Technical Service Bulletin

Subject: FRONT DOOR INTERFERES WITH REAR DOOR GARNISH (5-DOOR HATCHBACK)	Bulletin No.: 09-028/25
	Last Issued : 07/28/2025

Old	New
Clip		
Hole at the door sheet metal panel

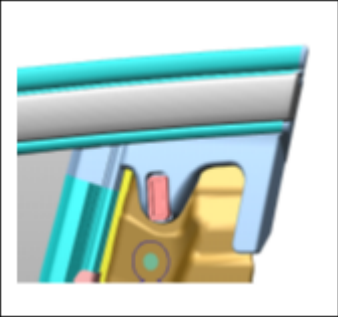
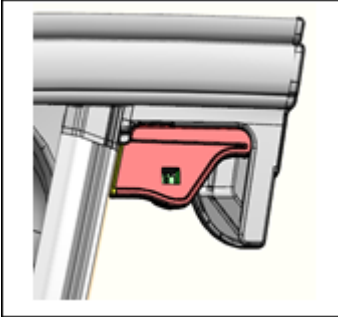
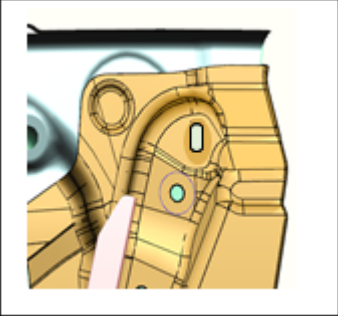
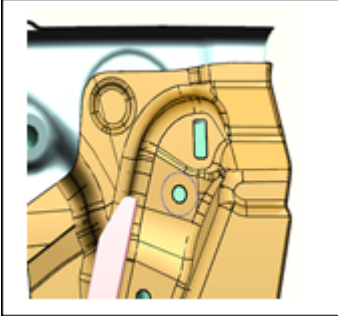
- Phase 1
 - Adhesive has been added between the front door glass run channel and the door panel.
- Phase 2
 - The shape of the front door glass run channel has been changed so as not to make contact with the rear garnish.
 - The shape of the clip at the rear side of the front door glass run channel has been changed for stronger fixing and the hole at the door sheet metal panel has been changed accordingly.

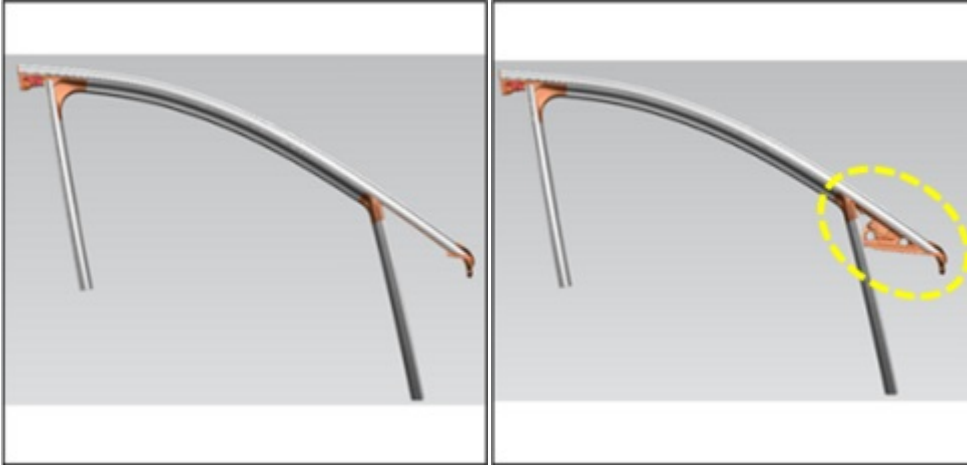
NOTE: There are two types of front door glass run channel.

- If the front door glass run channel obtained is BDMT-58/59-60ZJ or later level, remove and discard the sail garnish (1), which is originally installed on the vehicle according to the instructions on MGSS (SAIL GARNISH REMOVAL/INSTALLATION), before installing the front door glass run channel.

BDMT-58/59-60ZH

BDMT-58/59-60ZJ or later

Discard
(1) Sail garnish
(BCJH-58-621)

Front door glass run channel and sail garnish are integrally formed
